**HATFIELD MCCOY REGINAL RECREATION AUTHORITY
LINCOLN COUNTY, WEST VIRGINIA
IVY BRANCH TRAILHEAD CABINS PROCUREMENT & INSTALLATION**

ADDENDUM #1

APRIL 30, 2021

THRASHER PROJECT #030-10042

LAYOUT TAB: 3 QUANTITIES
CAD FILE: R:\030\030-10042-BD-AT LAUNCH-HATFIELD MCCOY- Drawing\Cabins\Cabin Installation\10042-CABINS-INSTALL-GEN NOTES.dwg
PLOT DATE/TIME: 4/30/2021 7:44 AM

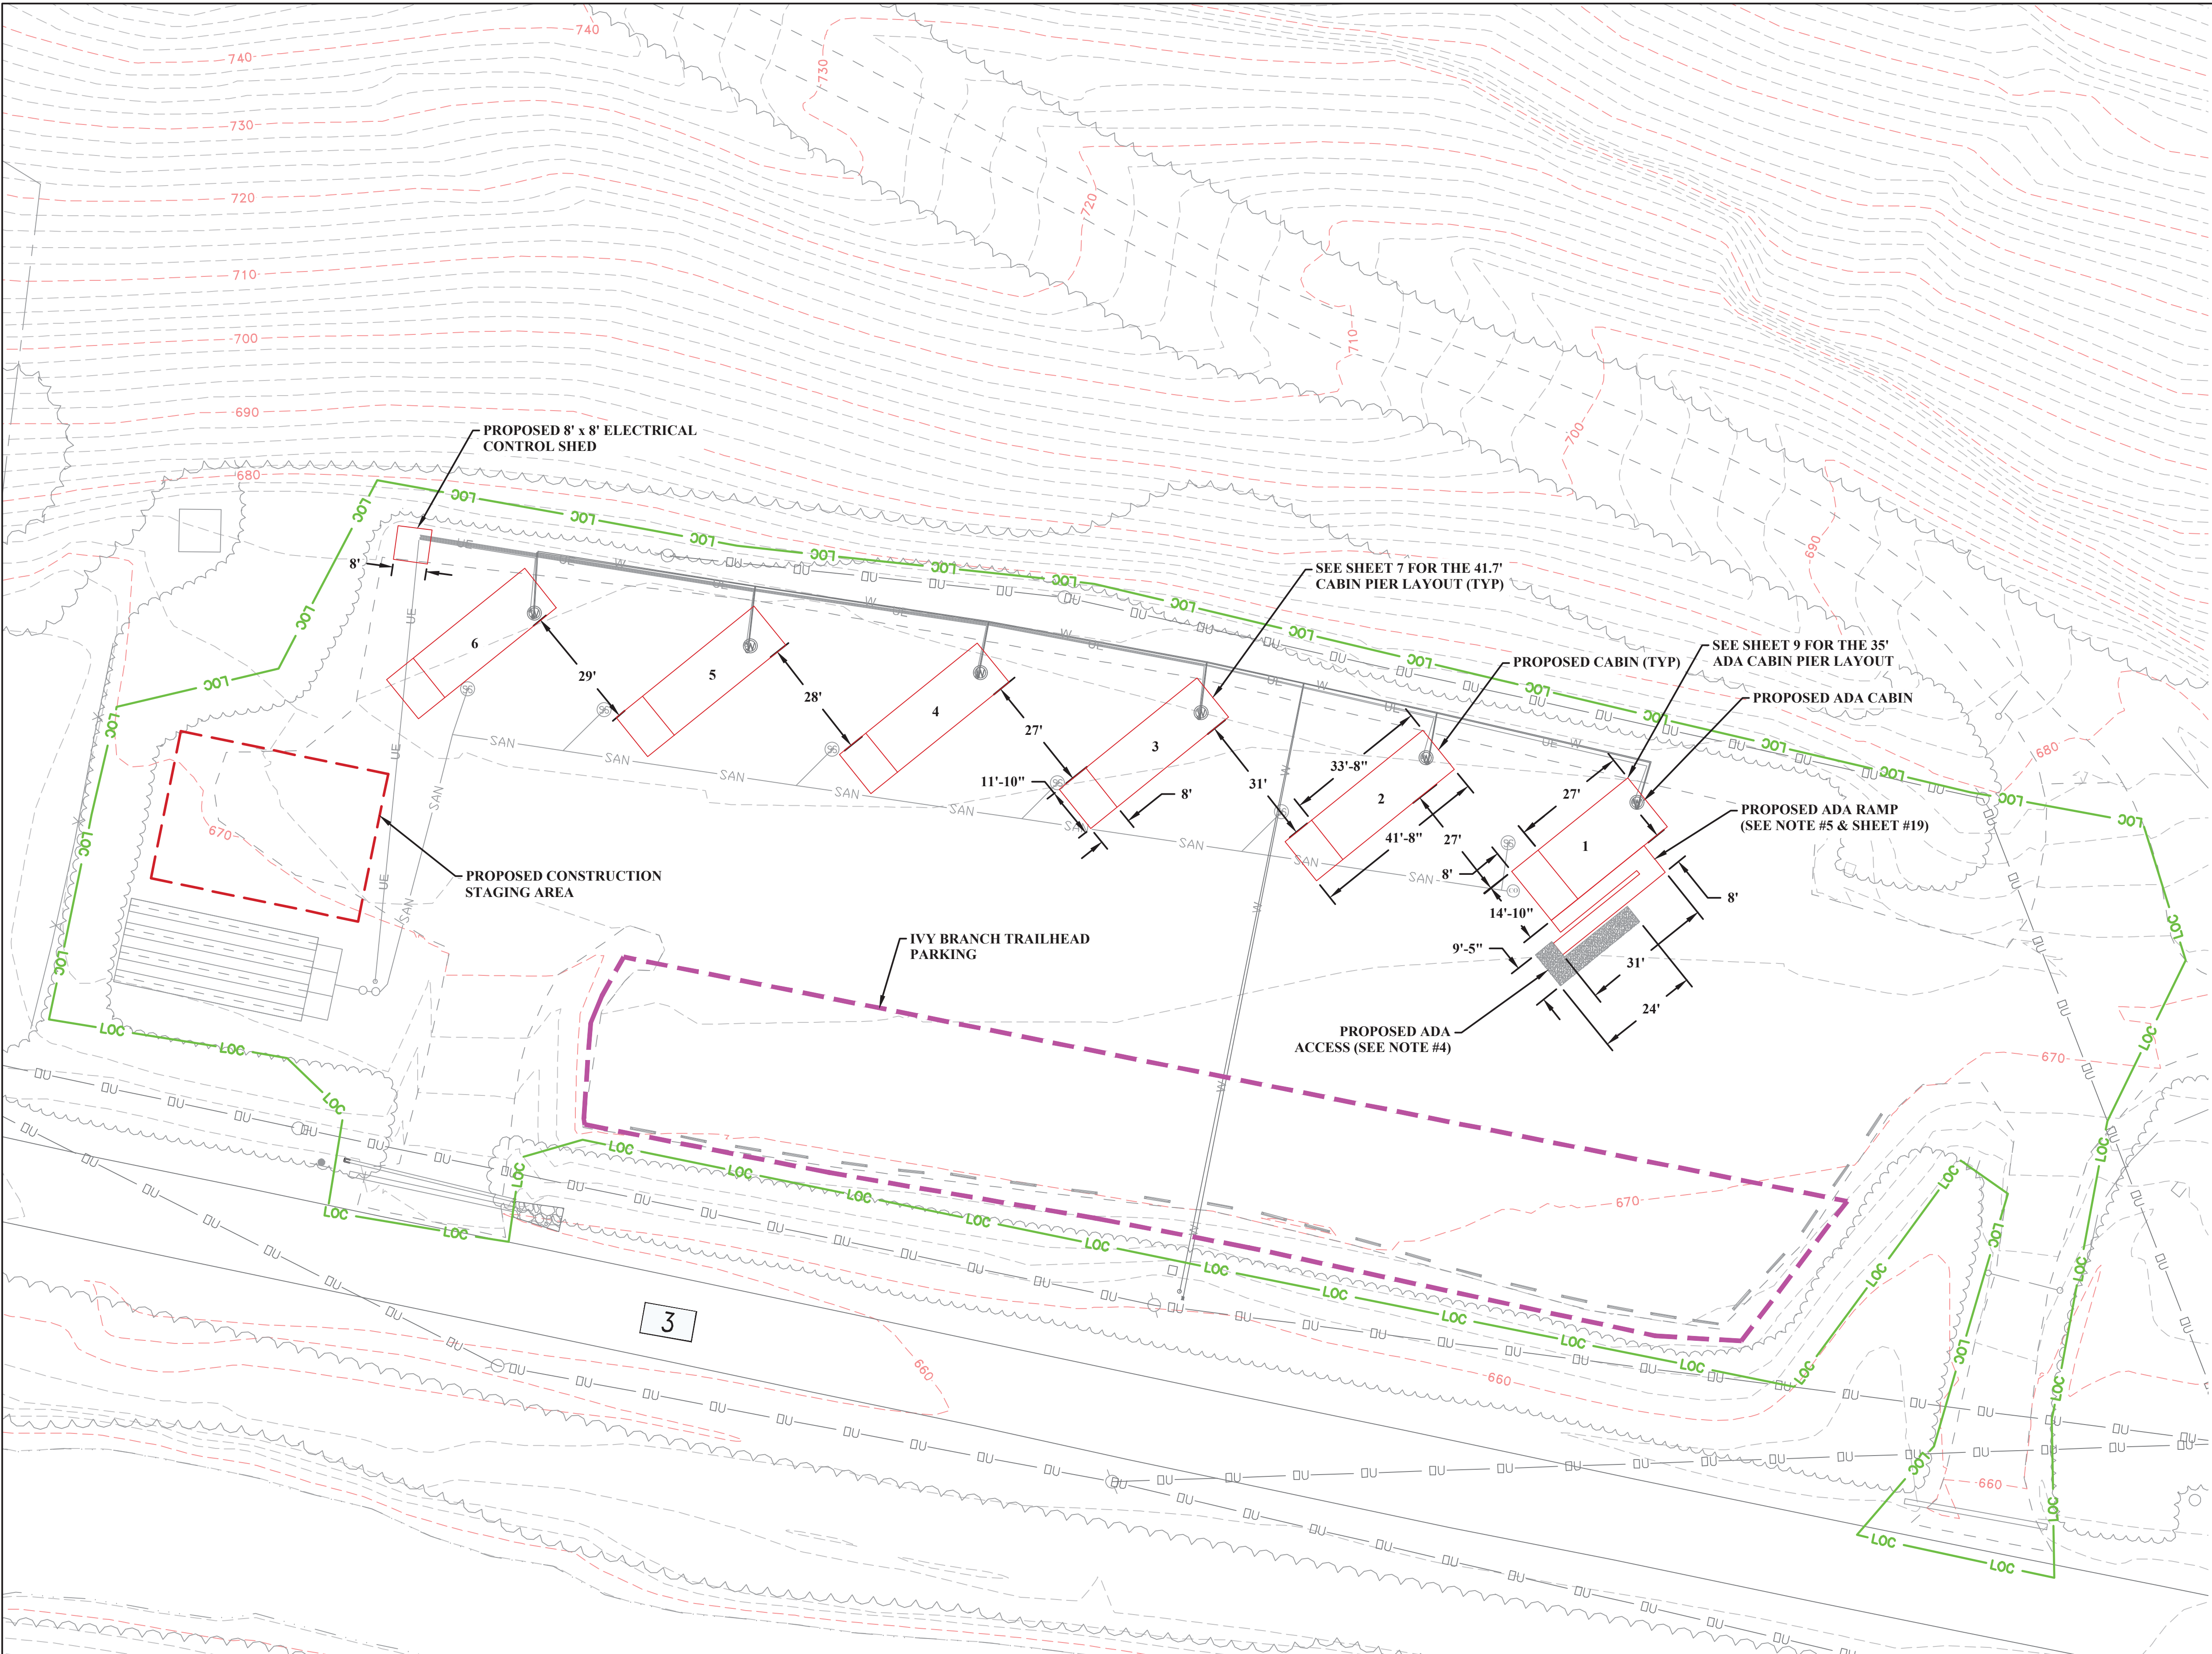
Sheet 3 of the Plan Set was revised to include Bid Items 5 and 19-22. Items 5-13 were renumbered to reflect the changes.

1	JRH	4/29/21	ADDED ITEMS 5 & 19-22, REVISED ITEM #5-13
NO.	BY	DATE	DESCRIPTION
